Peach Bottom Atomic Power Station, Units 2 and 3  
Renewed Facility Operating License Nos. DPR-44 and DPR-56  
NRC Docket Nos. 50-277 and 50-278

Subject: License Amendment Request to Remove LCO 3.5.1 Note

**ATTACHMENT 1**

**Evaluation of Proposed Changes**

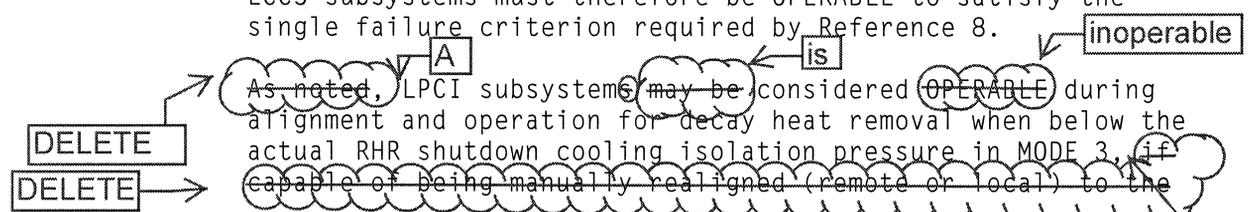
(continued)  
since transferring from the shutdown cooling mode to the LPCI mode could result in pump cavitation and voiding in the suction piping, resulting in the potential to damage the RHR System, including water hammer.

DELETE

~~LPCI mode and not otherwise inoperable. Alignment and operation for decay heat removal includes when the required RHR pump is not operating or when the system is realigned from or to the RHR shutdown cooling mode. This allowance is necessary since the RHR system may be required to operate in the shutdown cooling mode to remove decay heat and sensible heat from the reactor. At these low pressures and decay heat levels, a reduced complement of ECCS subsystems should provide the required core cooling, thereby allowing operation of RHR shutdown cooling when necessary. One LPCI subsystem shall be declared inoperable when MO-34A(B) and MO-39A(B) are simultaneously open in the same subsystem (one or both subsystems) with no Emergency Diesel Generators (EDGs) declared inoperable to ensure compliance to References 7, 14, and 15 single failure analyses (Ref. 11).~~
